## **ADDENDUM NO. 2**

**Project:** CITY OF GREAT FALLS INDOOR AQUATICS AND RECREATION CENTER  
**Project No.:** 20-019  
**Date:** OCTOBER 1, 2021  
**Bid Date:** OCTOBER 13, 2021

UNFACTORED DEAD LOADS: 700 LBS  
UNFACTORED LIVE LOADS, WORST CASE FOR FULL SPEED ESTOP AT FULL TENSION: 4400 LBS  
TYPICAL LATERAL LIVE LOADS IN ALL DIRECTIONS: 10%

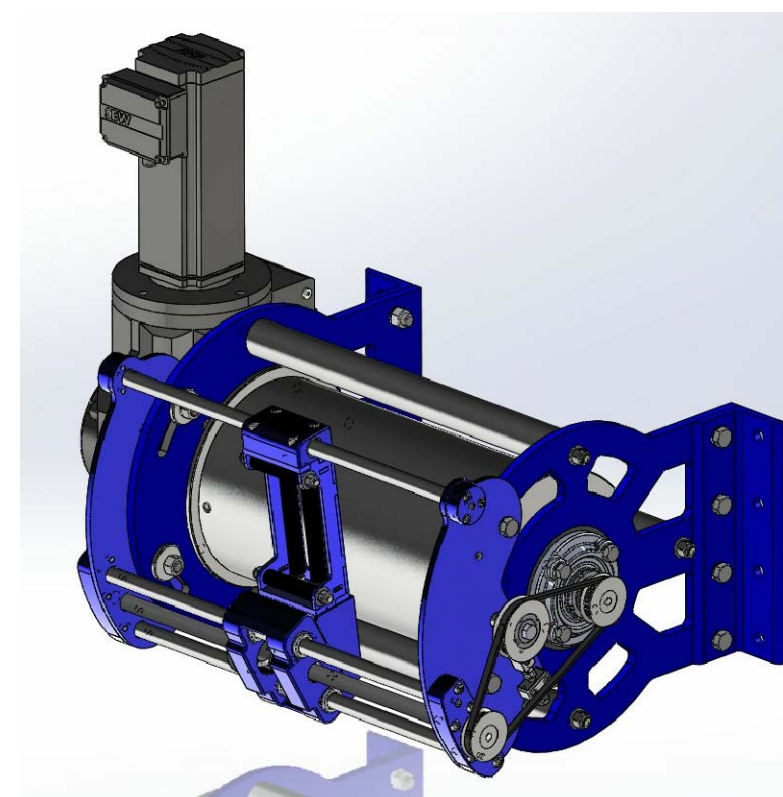
- ITEM NO. 4 **CLARIFICATION:** Section 01 20 00 Alternate #4: Military Training Equipment drawing (See Attachment "B").
- ITEM NO. 5. Section 07 21 16 **DELETE:** Part 1.1.A.2. Soundproofing Acoustical Membrane.

DESIGNED BY:	RLT
CHECKED BY:	SWM
DATE:	08/06/2021
PROJECT NUMBER:	20-019
SHEET NUMBER:	<b>S3.0</b>

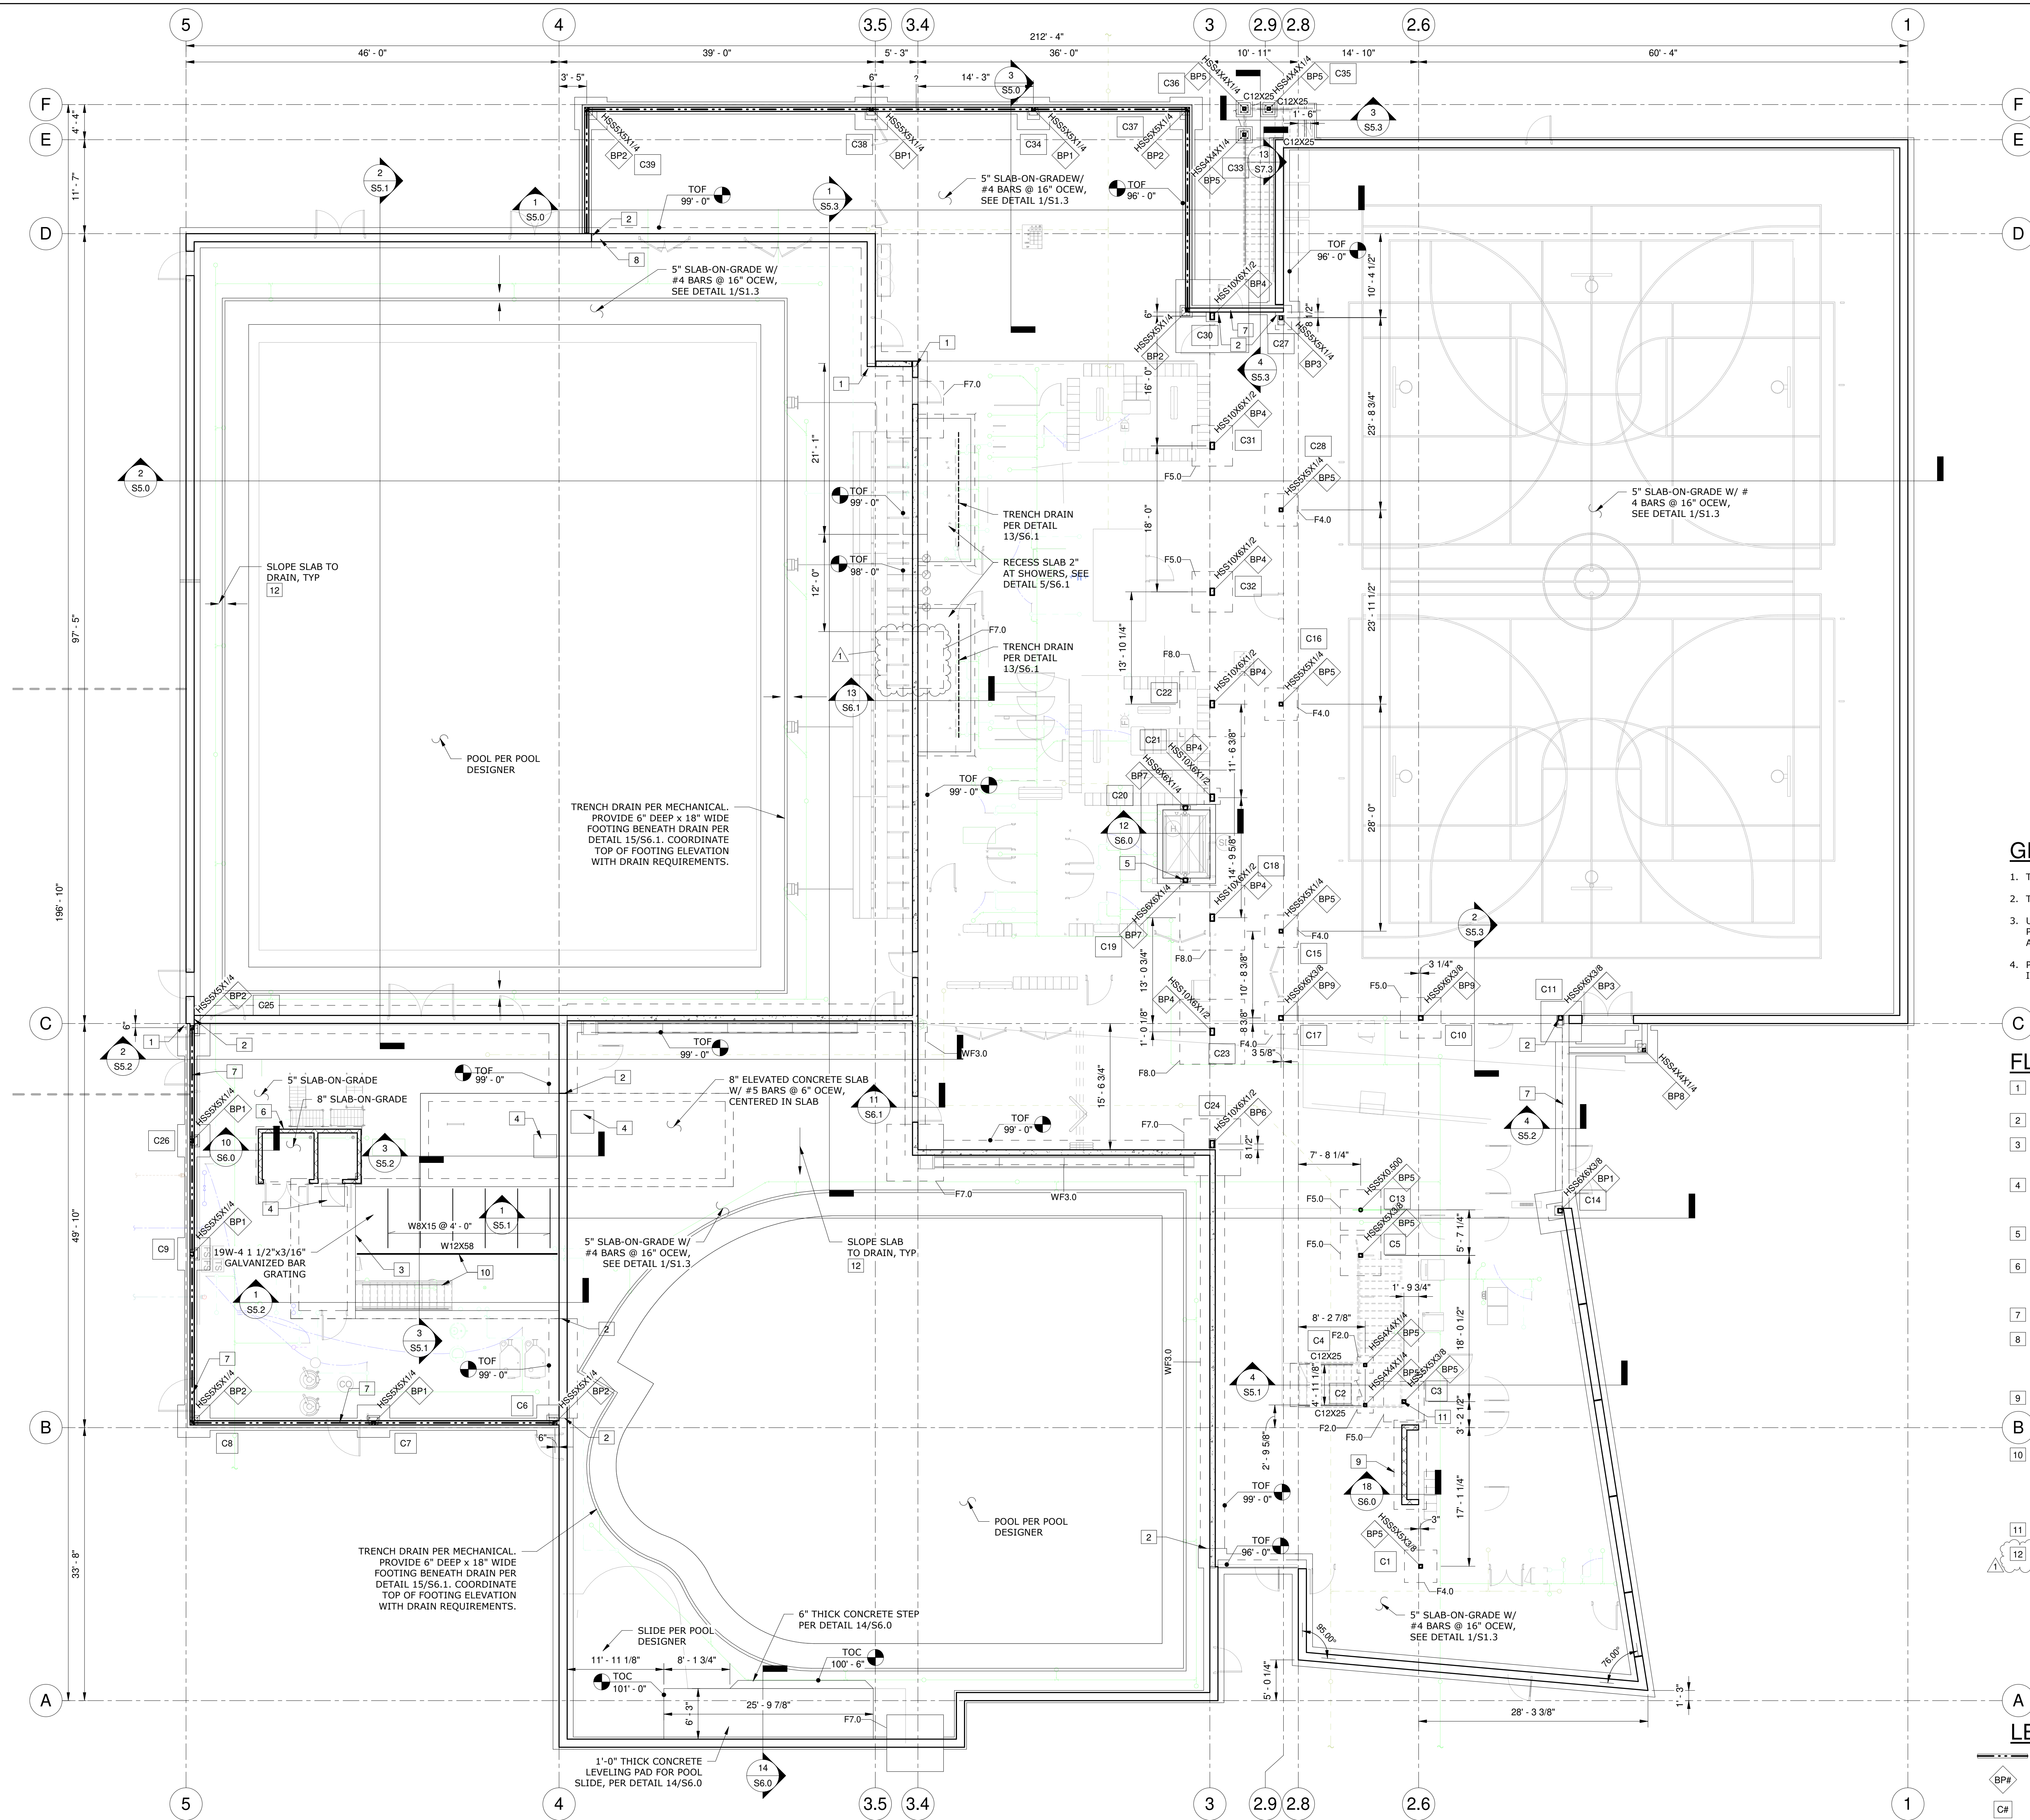
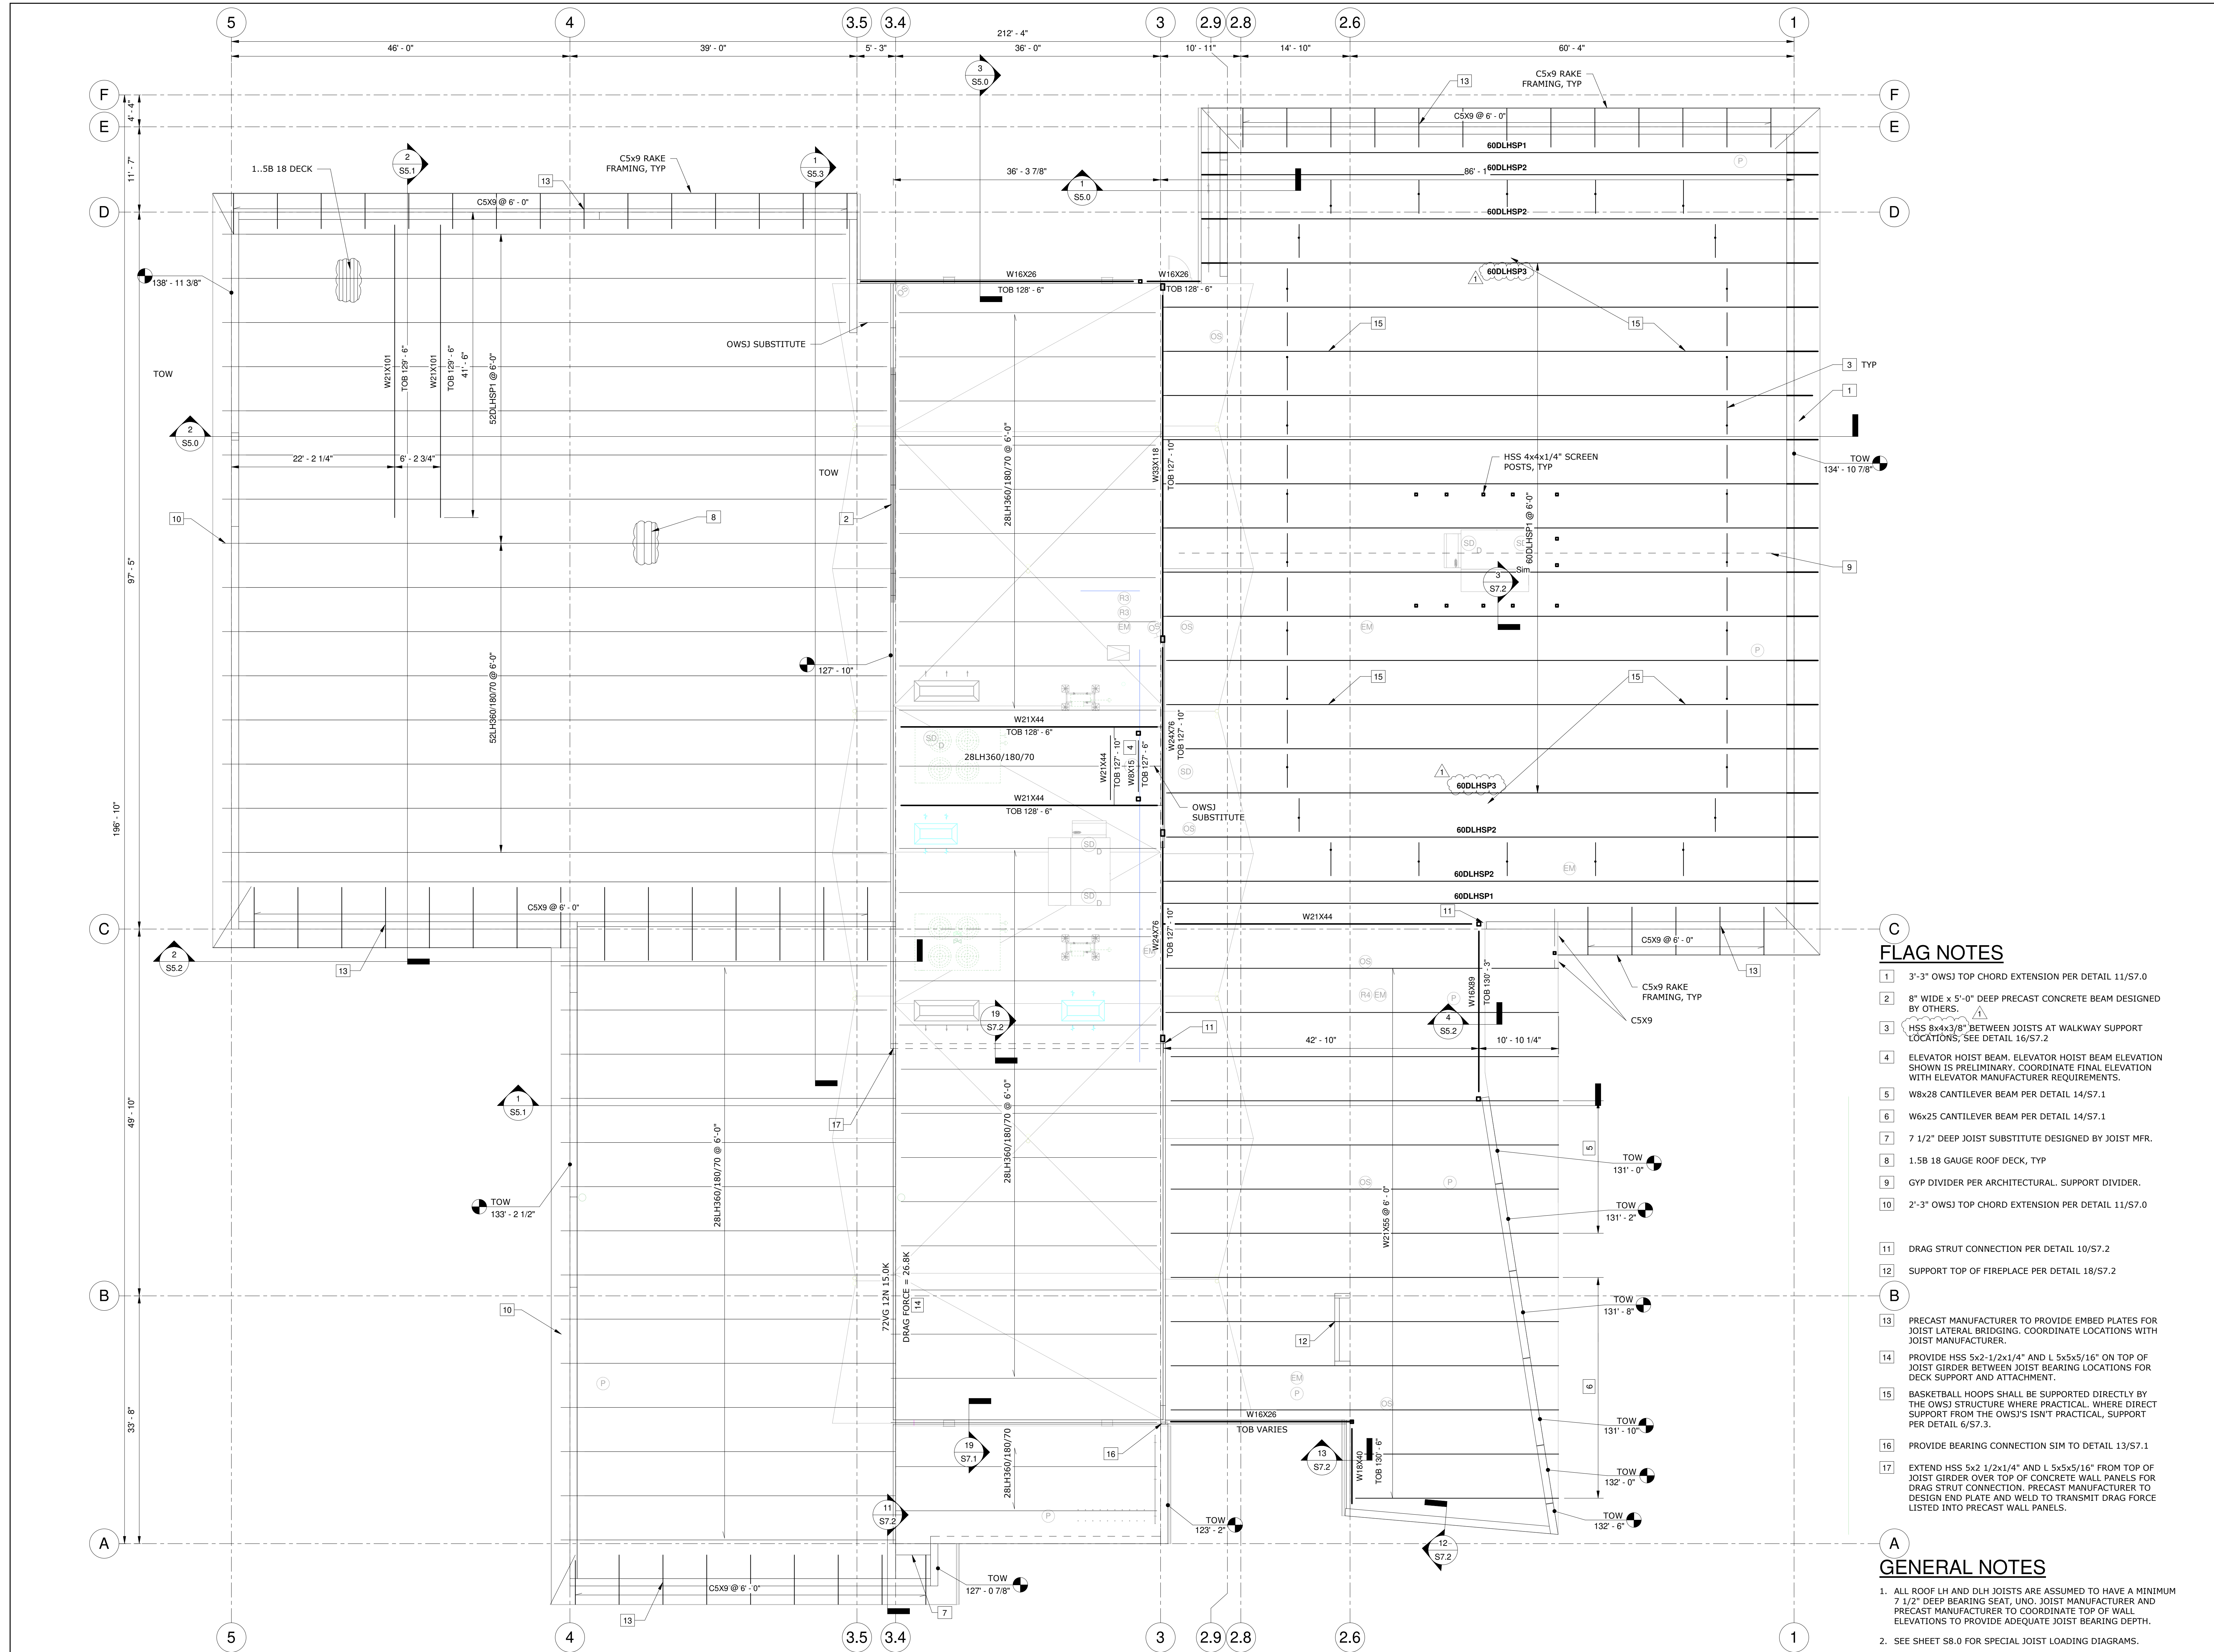
- ITEM NO. 22 **CHANGE:** (4) Structural Sheets updated (See Attachment "E")  
S3.0: Provided slab slope clarification and shifted a footing.  
S4.0: Added 1-special joist callout  
S7.2: Adjusted 3-joist details  
S8.0: Adjusted several joist loading diagrams and added a clarification note.
